## **ADDENDUM NO. 2**

**Project:** CITY OF GREAT FALLS INDOOR AQUATICS AND RECREATION CENTER  
**Project No.:** 20-019  
**Date:** OCTOBER 1, 2021  
**Bid Date:** OCTOBER 13, 2021

**ATTACHMENT "B"**

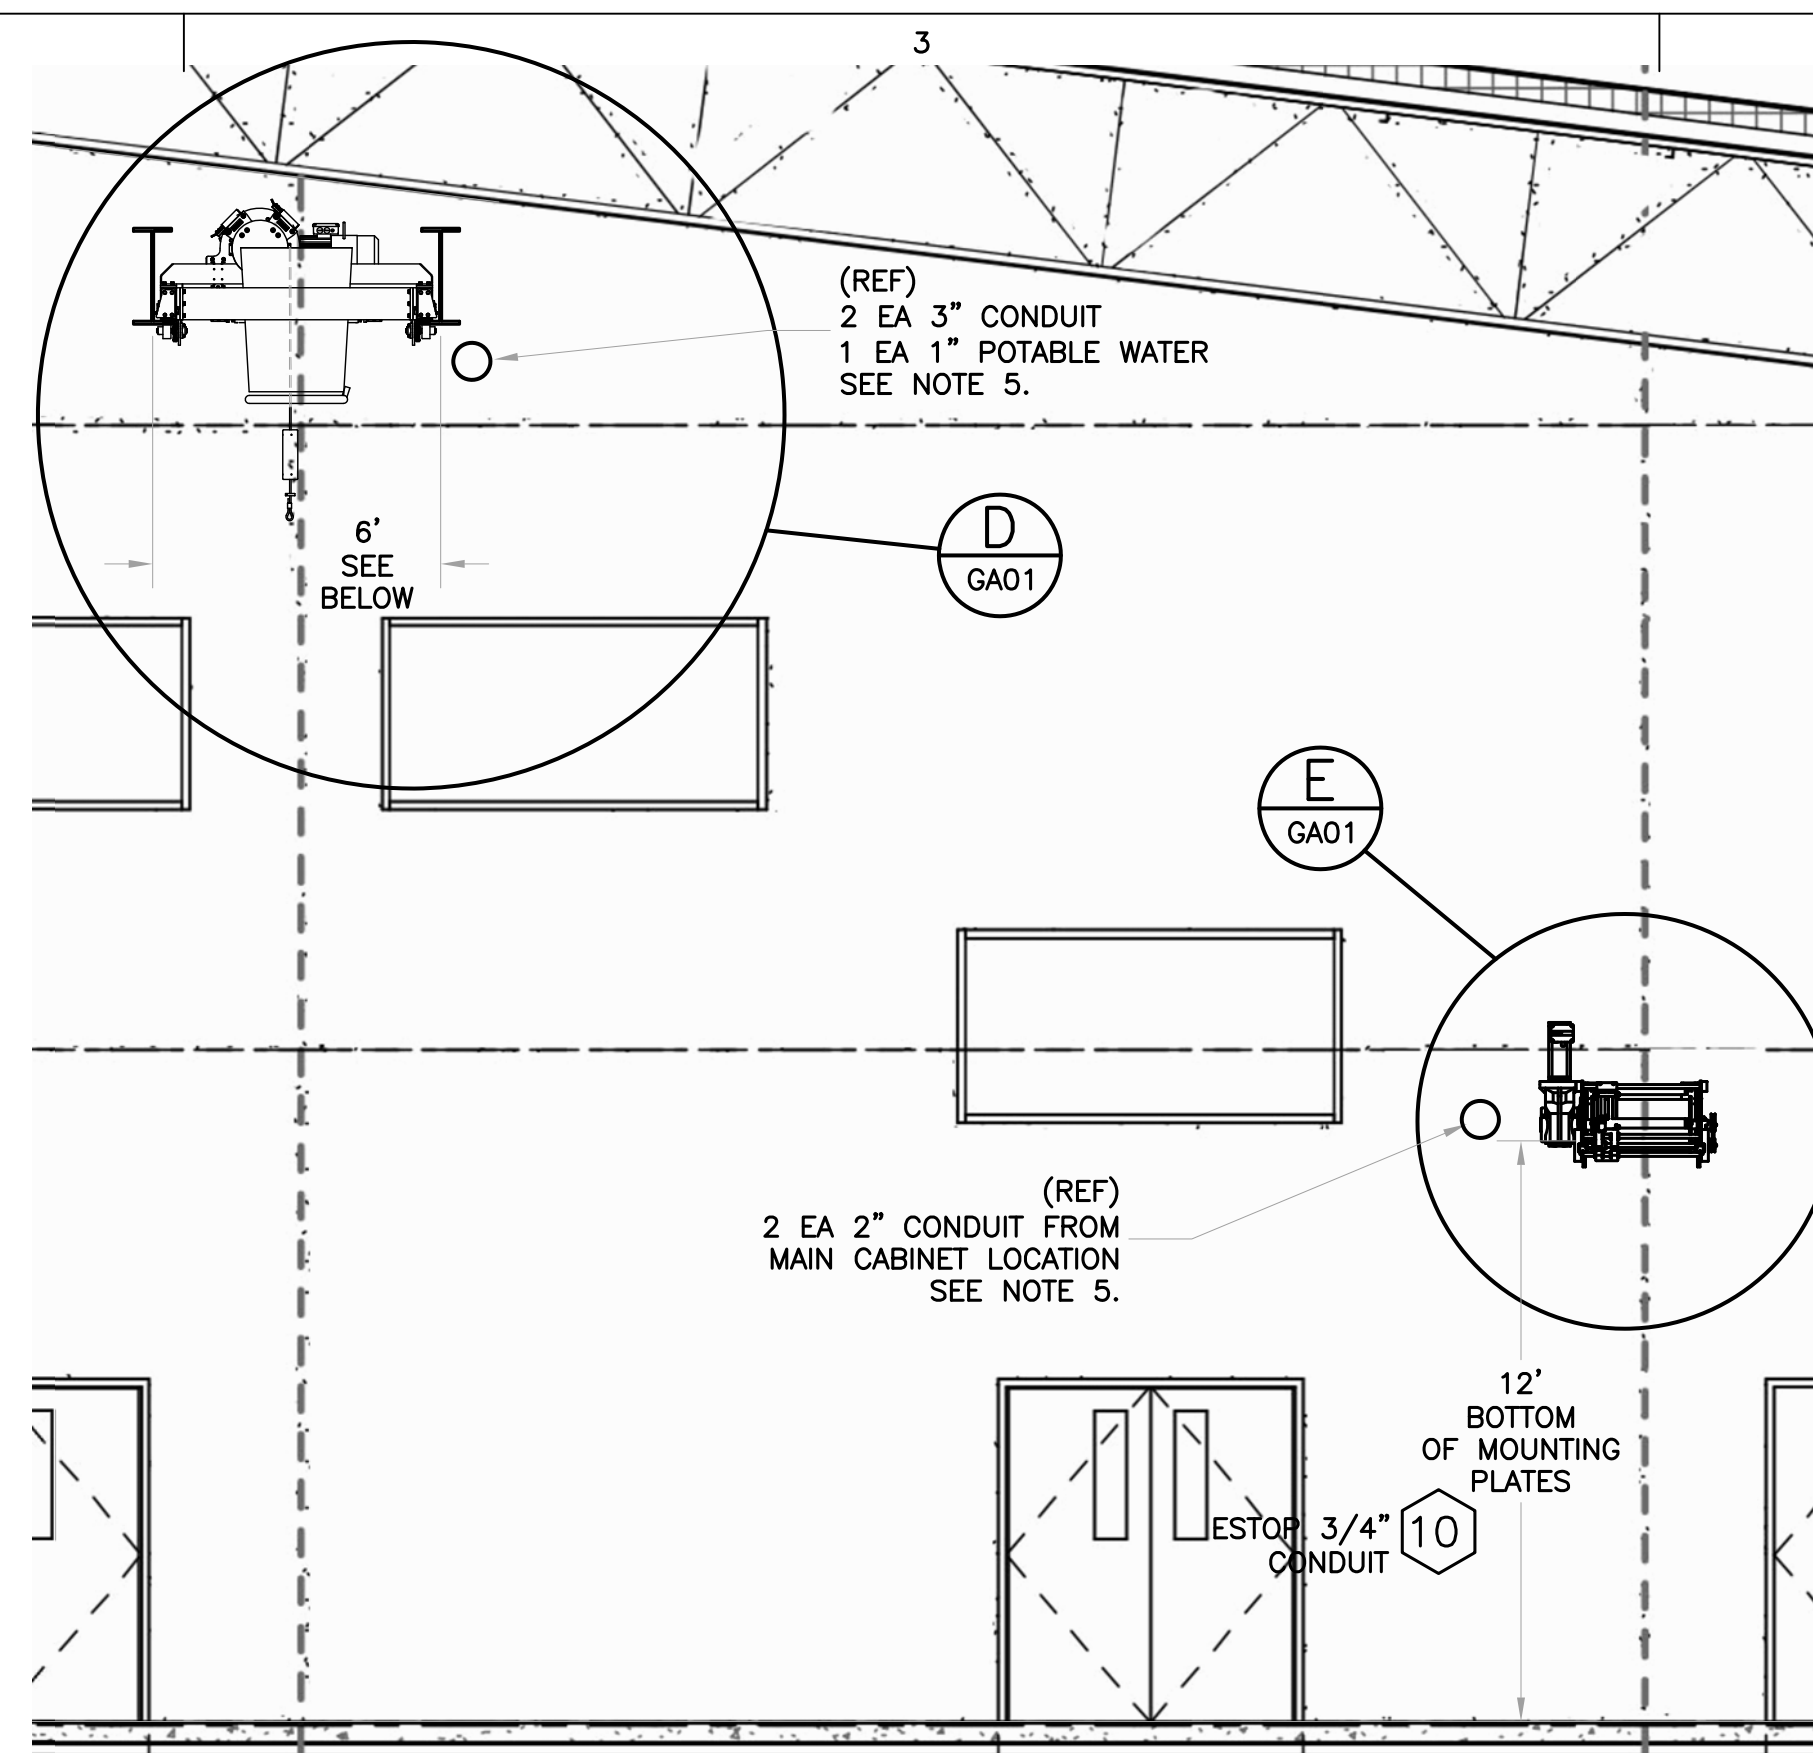
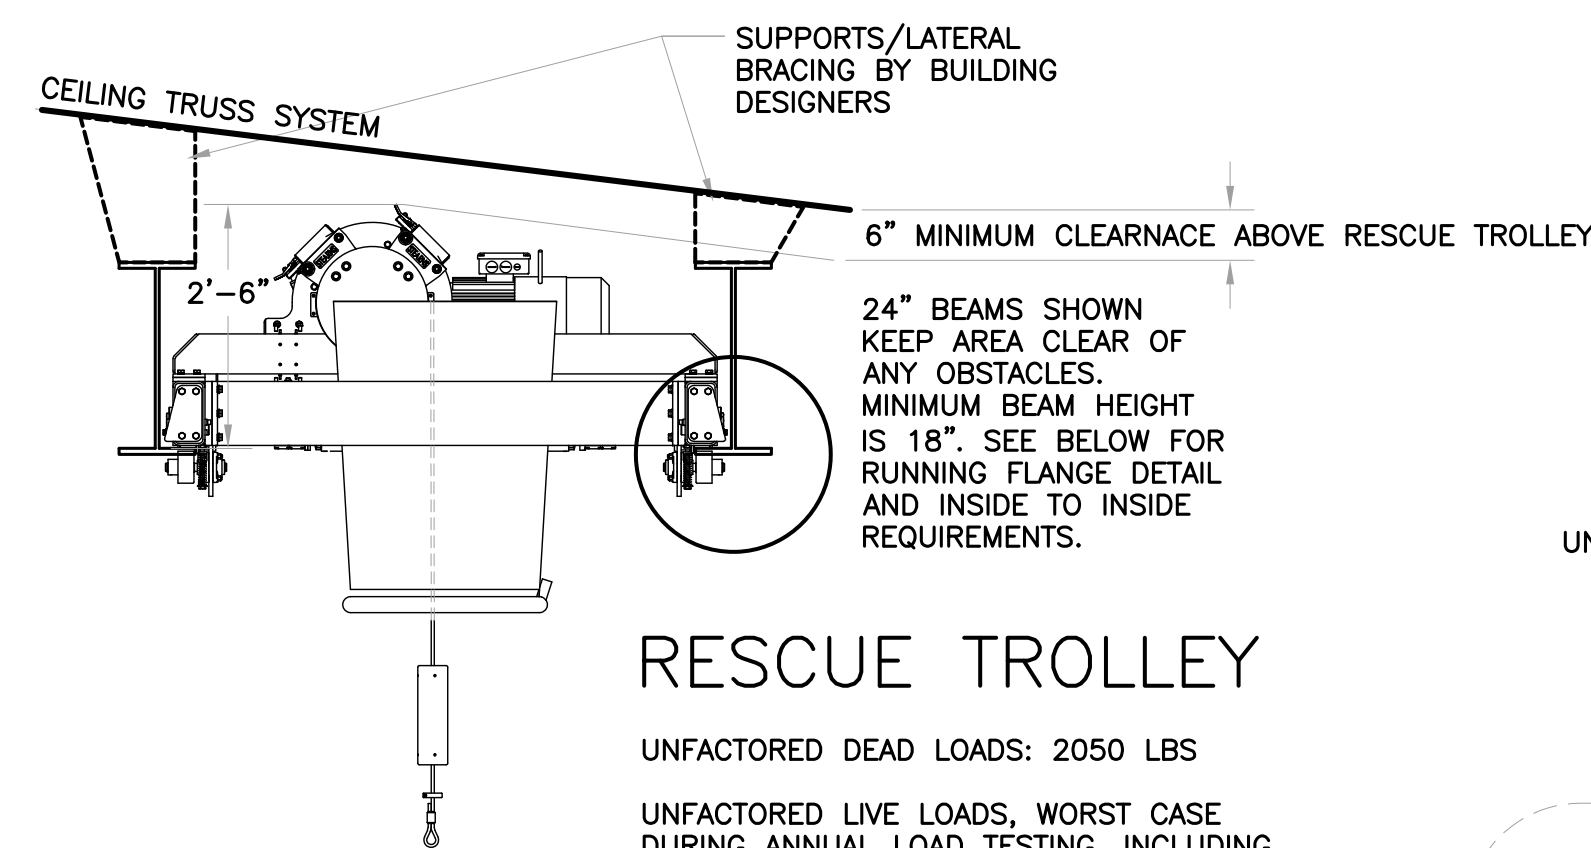
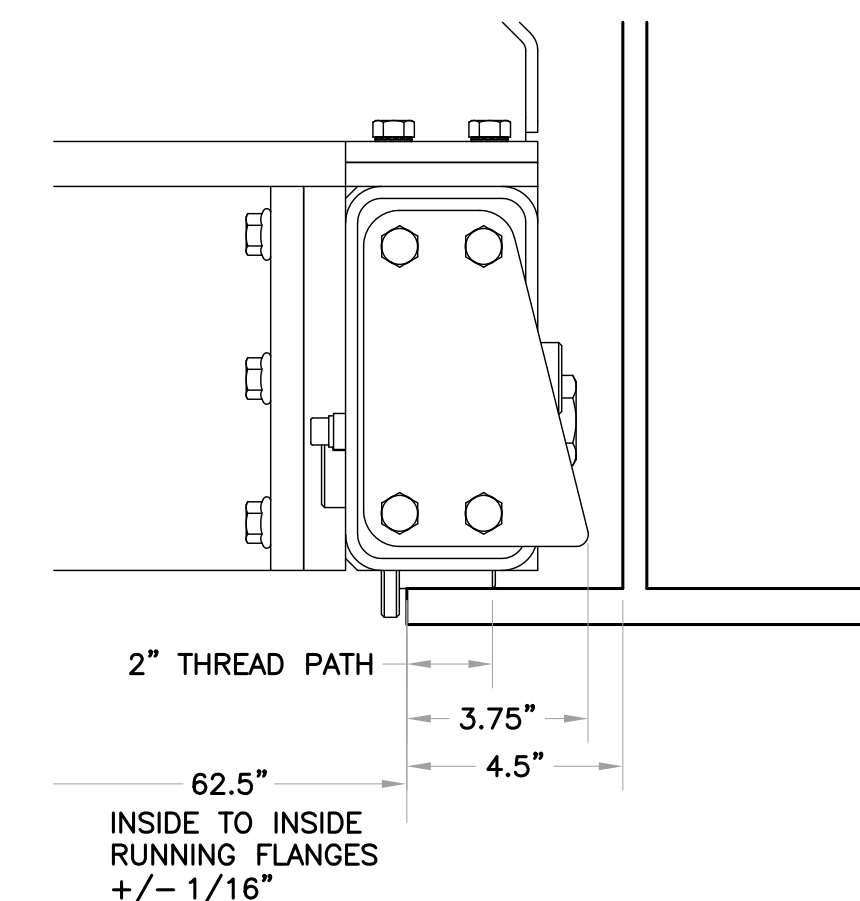
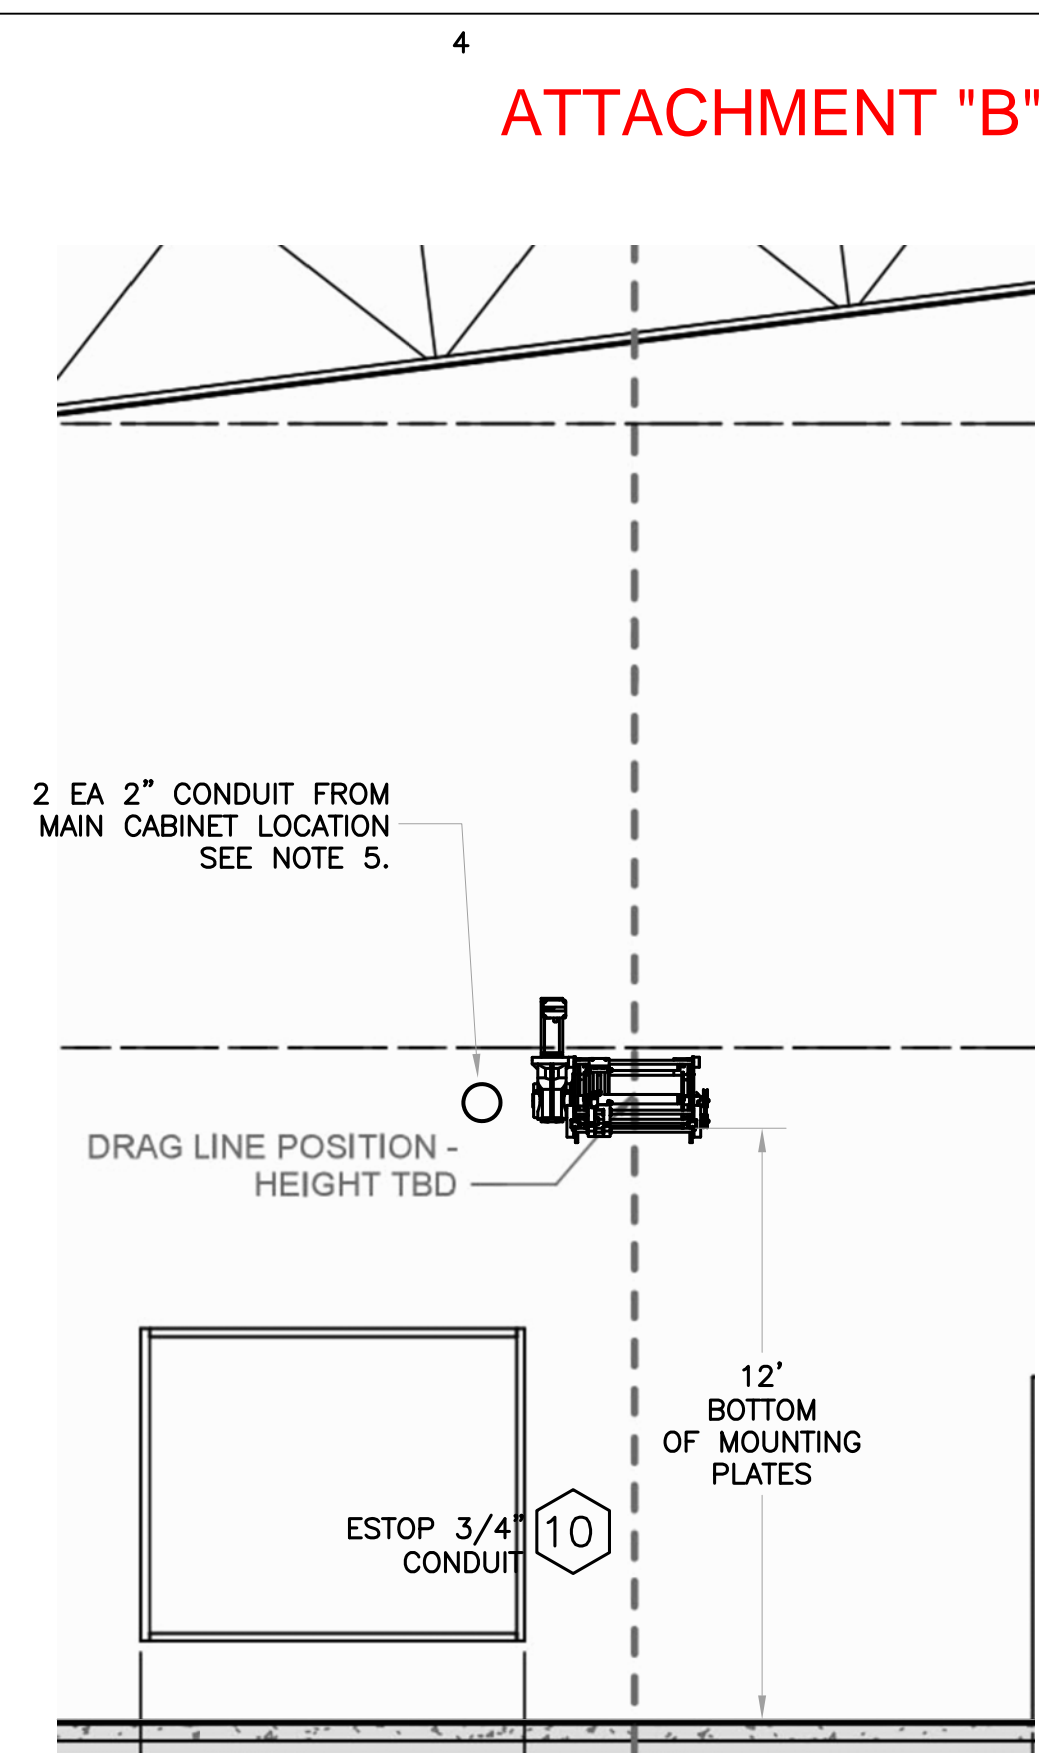
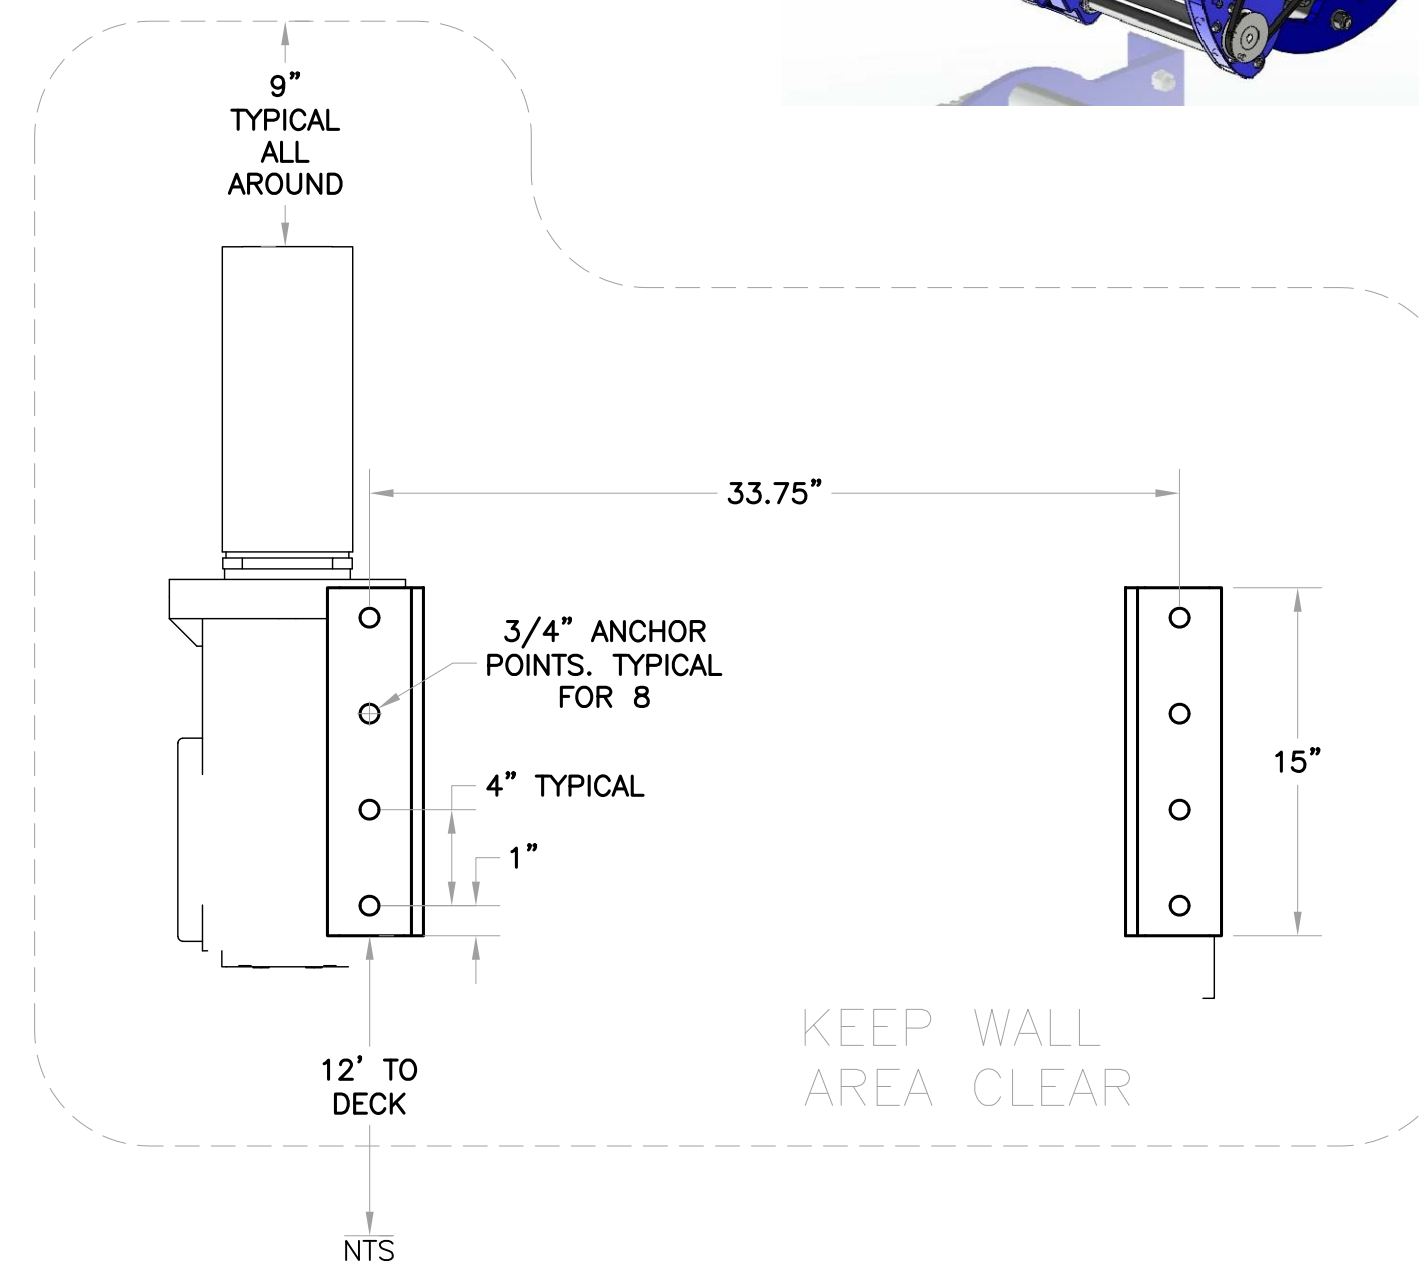
- ITEM NO. 4 **CLARIFICATION:** Section 01 20 00 Alternate #4: Military Training Equipment drawing (See Attachment "B").
- ITEM NO. 5. Section 07 21 16 **DELETE:** Part 1.1.A.2. Soundproofing Acoustical Membrane.
